KEYSTONE XL PIPELINE PROJECT

0439-SD-P4-534.1-534.1-1

KEYSTONE XL PIPELINE PROJECT PIPELINE ROUTE VARIATION FORM			
1	<b>VARIATION TYPE:</b> Refinement: <input type="text"/> Reroute: <input type="text"/> Footprint: <input checked="" type="checkbox"/> Design: <input type="text"/> Centerline: <input type="text"/> Pump Station: <input type="text"/> Valve Site: <input type="text"/> CAR: <input checked="" type="checkbox"/>		
2	<b>LOCATION:</b> Sketch: <input type="text" value="Attached"/> Pictures: <input type="text" value="N/A"/> State: <input type="text" value="SD"/> County: <input type="text" value="LYMAN"/> Quad Map: <input type="text" value="N/A"/> Township: <input type="text" value="104N"/> Range: <input type="text" value="79W"/> Aerial Map: <input type="text" value="See attached map sheet"/> Section: <input type="text" value="26"/> Centerline: <input type="text" value="3/14/2012"/> MP: <input type="text" value="534.10"/> to <input type="text" value="534.12"/>

**KEYSTONE XL PROJECT**  
RV-0439-01 (VAR-22 MODIFICATION)

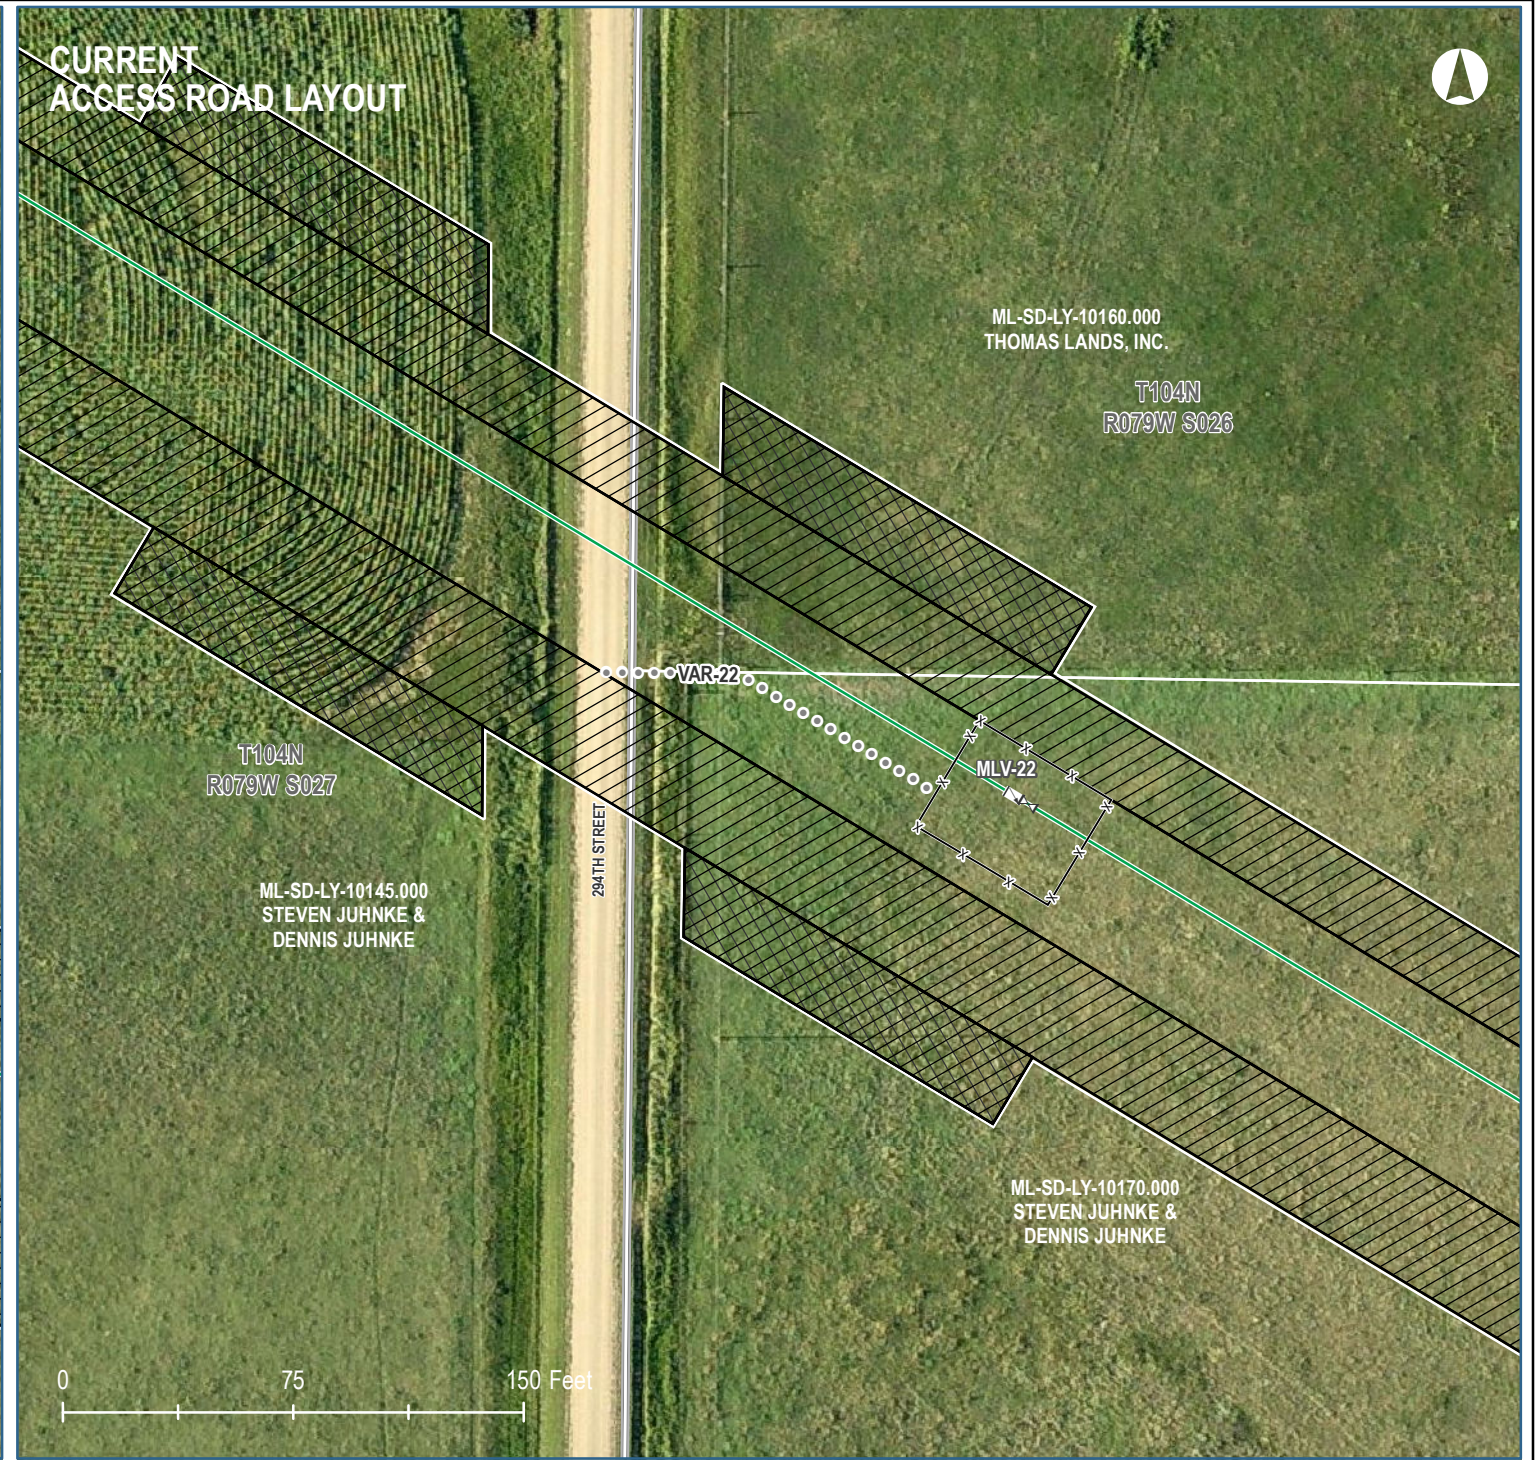
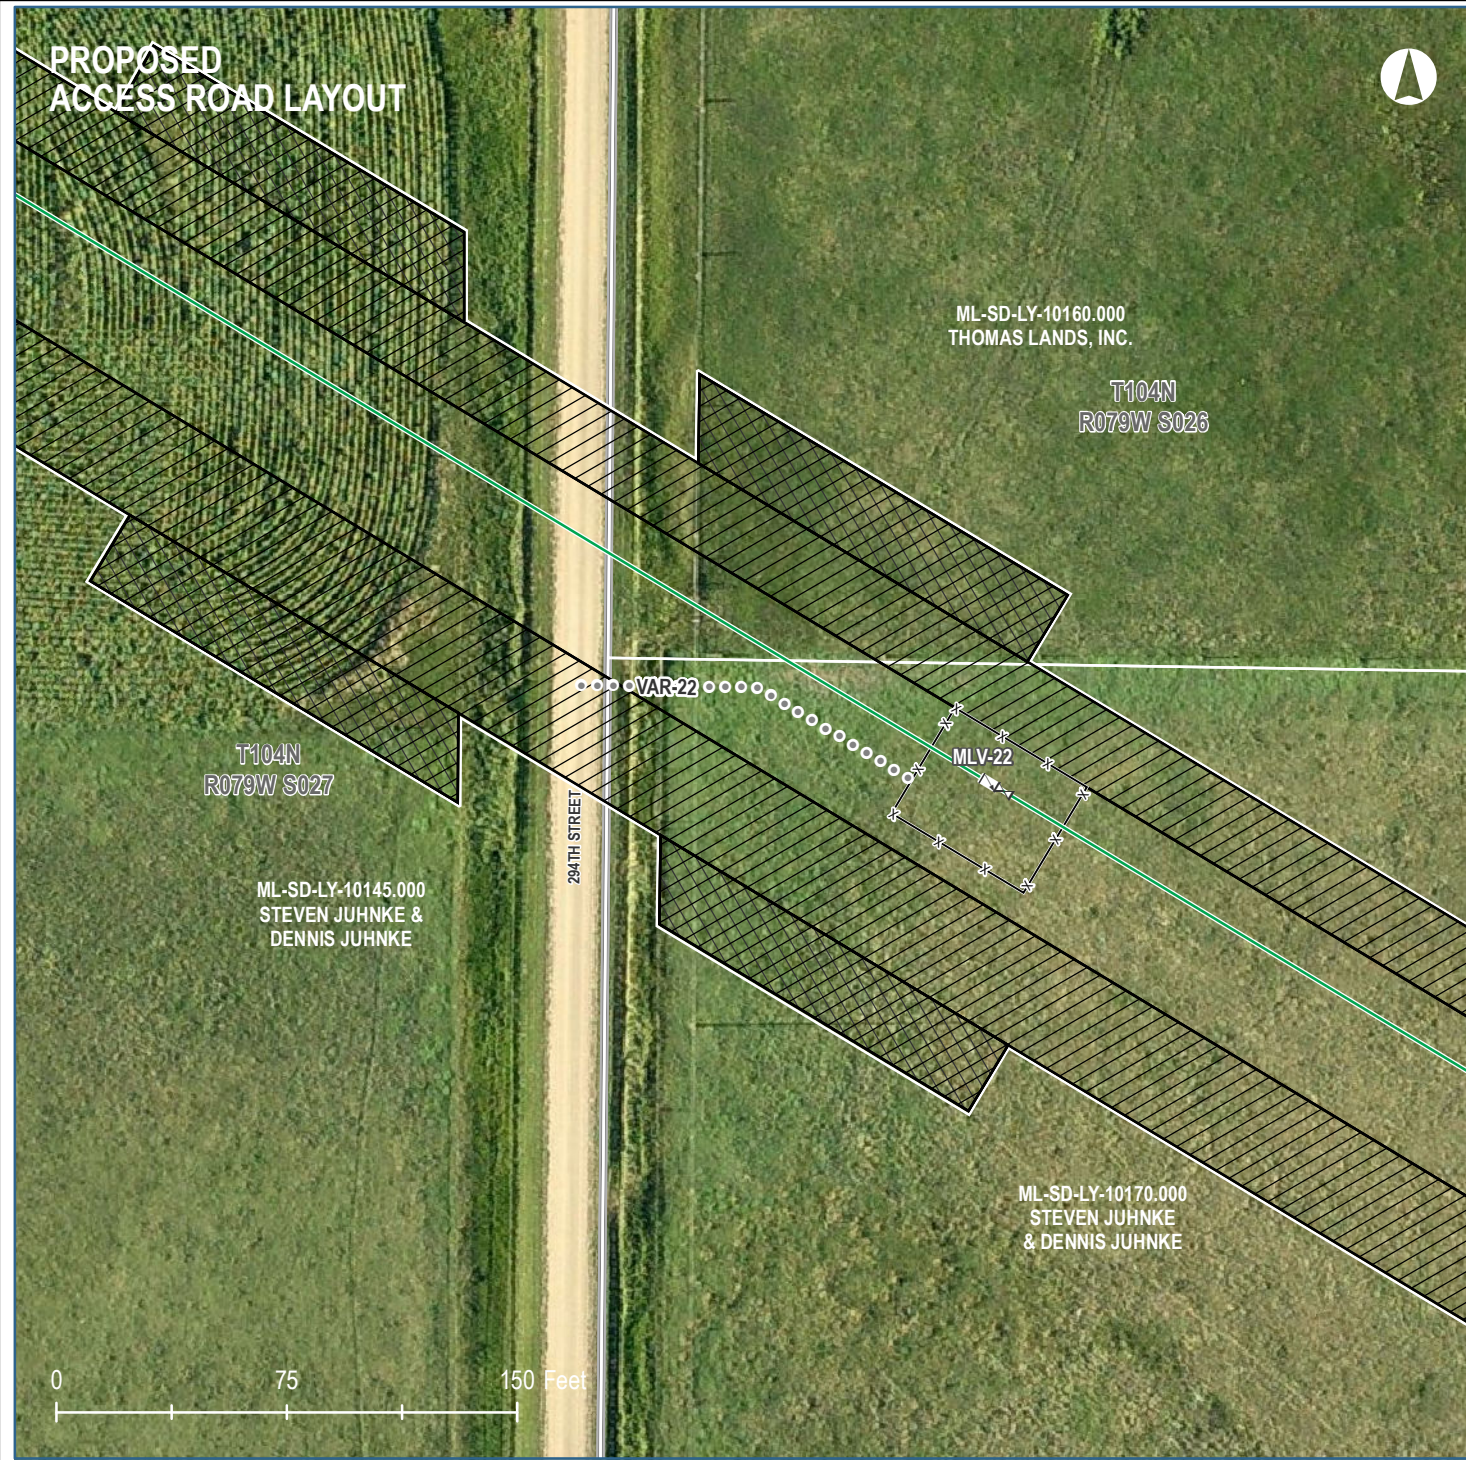
3	<b>REASON FOR ROUTE VARIATION</b> (Please include reason for route variation): The primary reason for this footprint change is to shift Valve Access Road VAR-22 ~ 9 ft. south to avoid VAR easement impact to ML-SD-LY-10160 (Thomas Lands, Inc.). Per land, this shift will avoid a gate at the property line between the two tracts. The landowners are afraid of livestock getting mixed if the gate was left open, and would prefer the access road stay on tract LY-10170.000  This footprint change is requested by Land.		
	<b>DETAIL ROUTE VARIATION</b> (Please describe route variation in detail): VAR-022 = Current length ~119.4 ft. and perpendicular distance from SD-LY-10160 southern property boundary of ~1 ft. Thus leaving ~14 ft. of AR easement inside SD-LY-10160. Proposed VAR length is ~ 117.3 ft. and offset (measured perpendicularly) to SD-LY-10160 southern boundary is ~9 ft. Proposed VAR-022 starts at 294th St. and continues for approximately 59 ft. prior to turning southeast and thus following the original VAR-022 path towards MLV-22 Valve Site.
